A63 Castle Street Improvement, Hull

DCO Documents Errata

TR010016/APP/6.1
HE51408-MMSJV-GEN-S0-RP-ZH-000016
~~27 August~~ 10 September 2019

| VOLUME 2 FIGURE 2.5.4 THE SCHEME PROPOSALS - SHEET 3 OF 6 | | | | | | | | | |

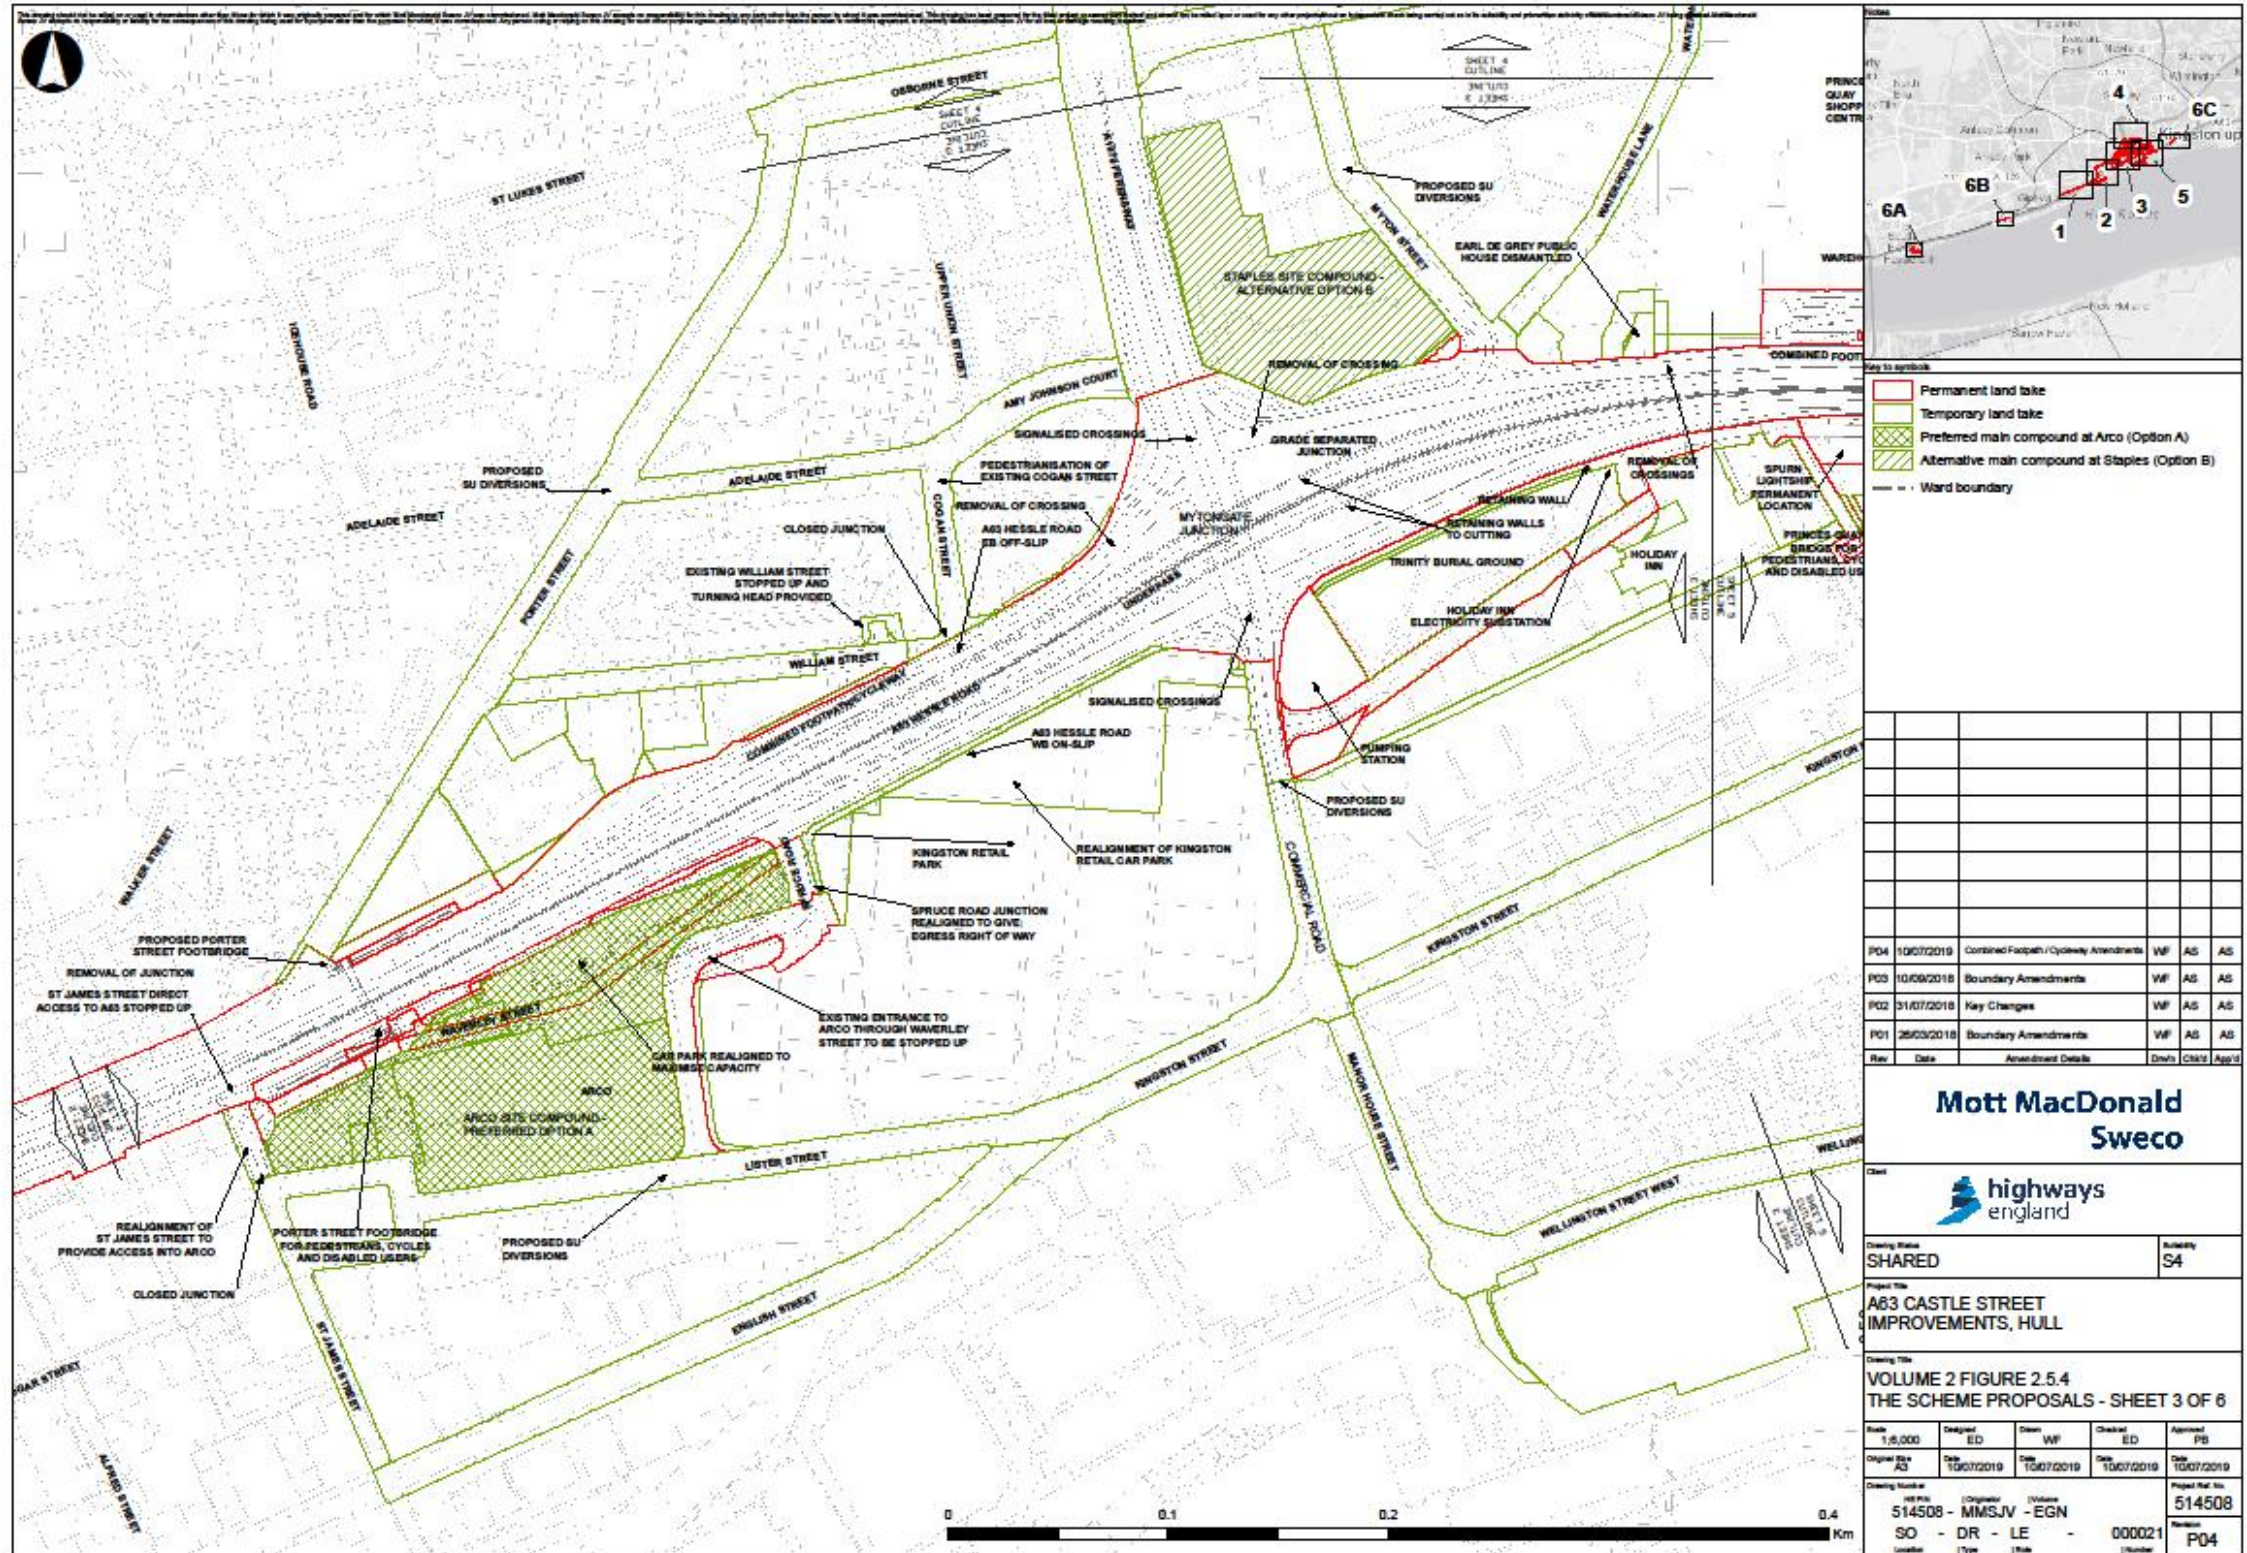
3.1.1 Replace ES Volume 2 Figure 2.5.4 The Scheme Proposals – Sheet 3 of 6 and Figure 2.5.6 The Scheme Proposals – Sheet 5 of 6 (APP-025) with the new Figures 2.5.4 and 2.5.6 below. Changes are as follows:

4.1.1 Replace ES Volume 2 Figure 10.2 Non-statutory designated sites (APP-036) with the new Figure 10.2 Non-statutory designated sites as below. Changes are as follows:

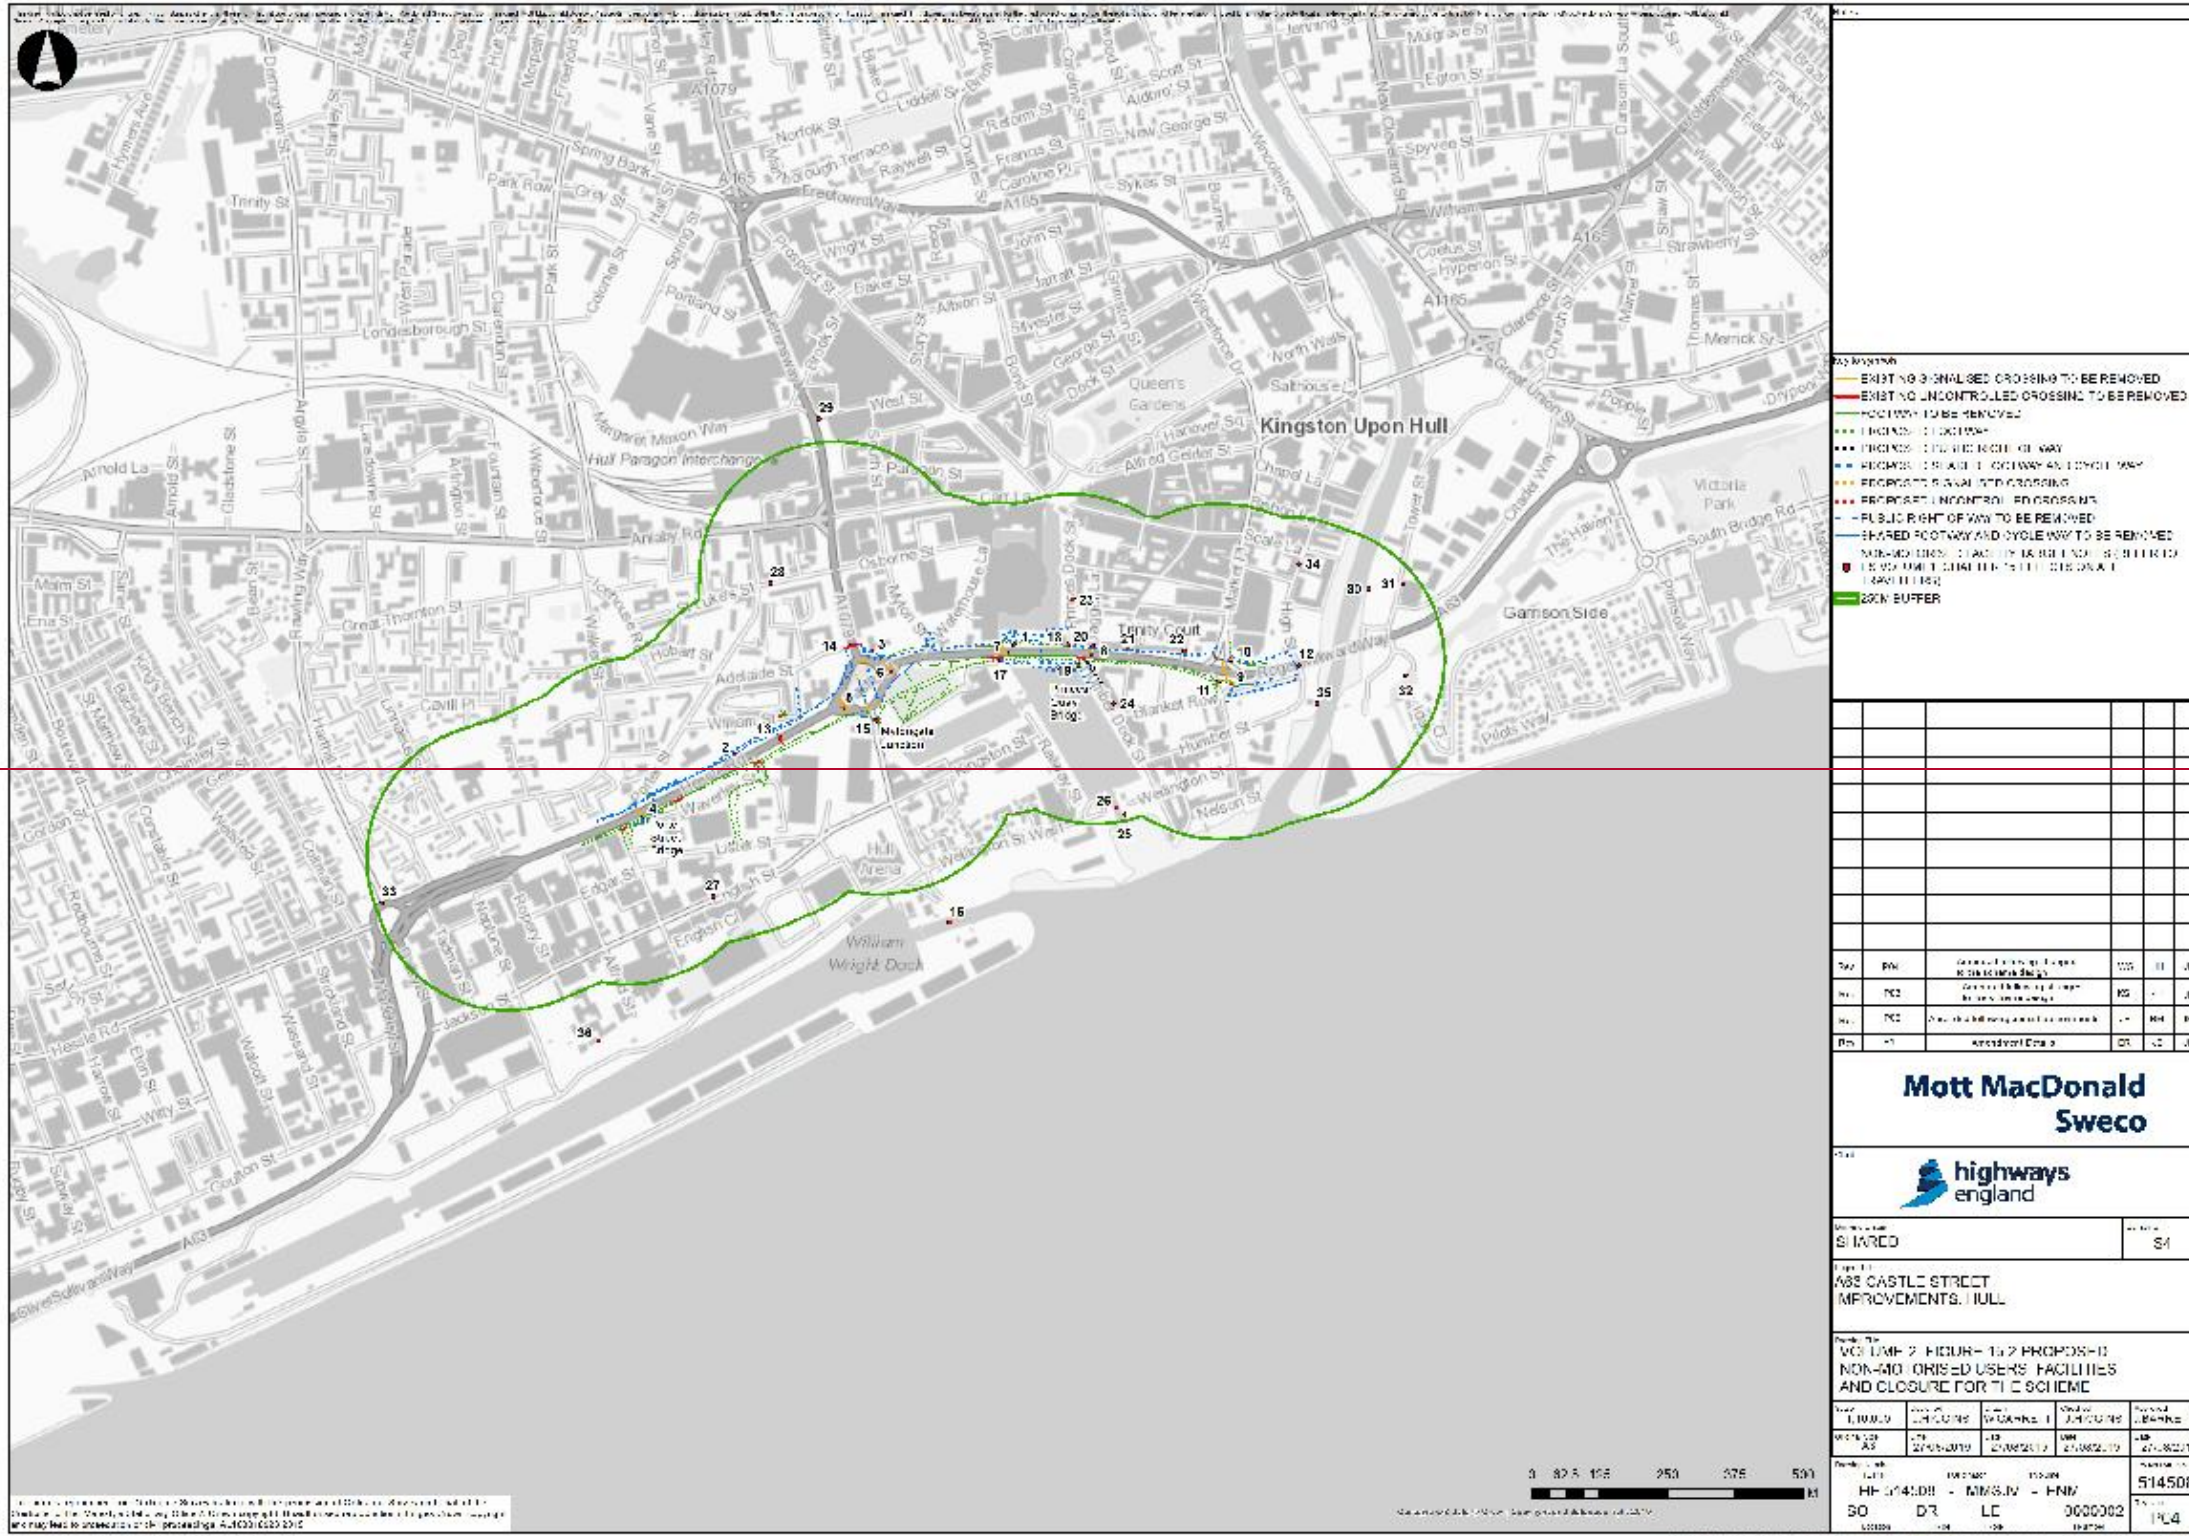
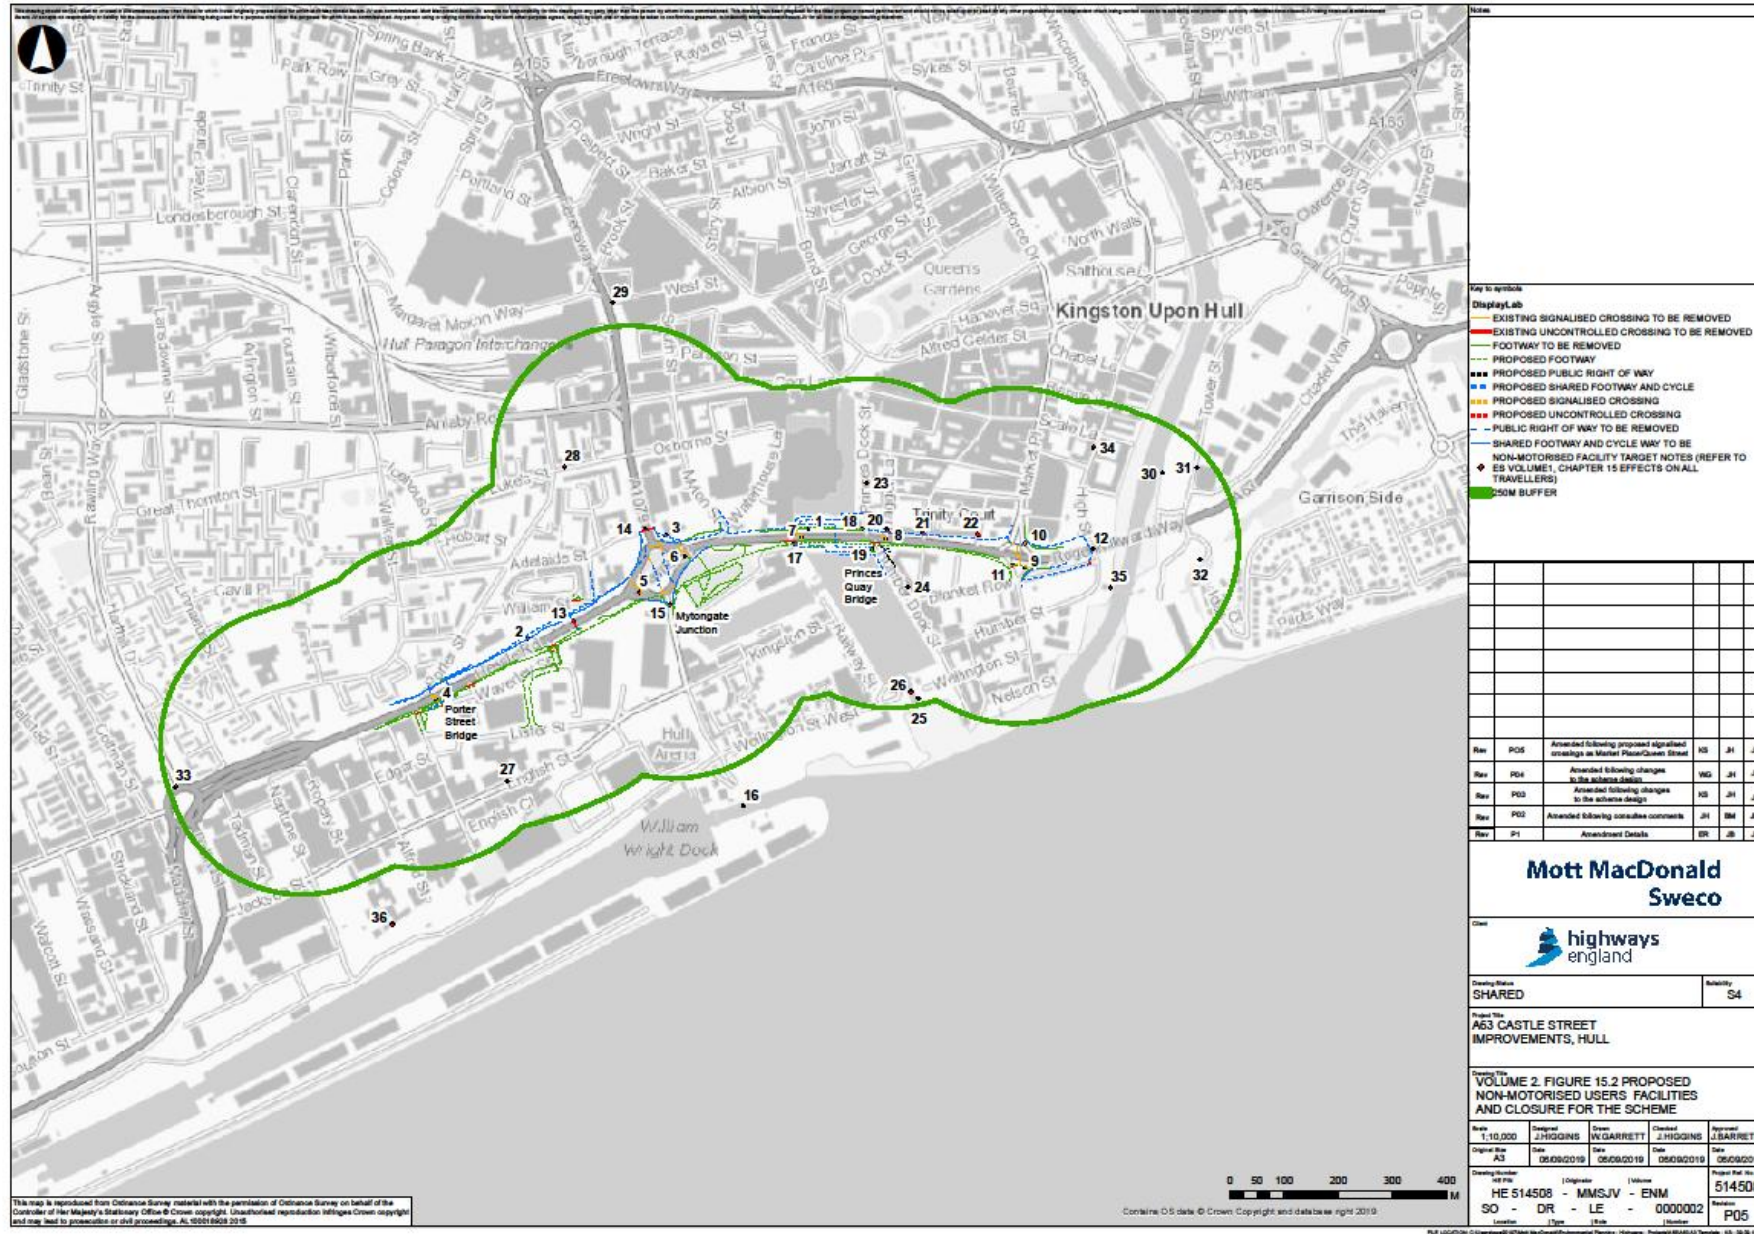
- The key has been replaced.
- Sammy's Point Site of Nature Conservation Interest (SNCI) has been added to Figure 10.2 as the mudflats are 250m from the Site boundary.
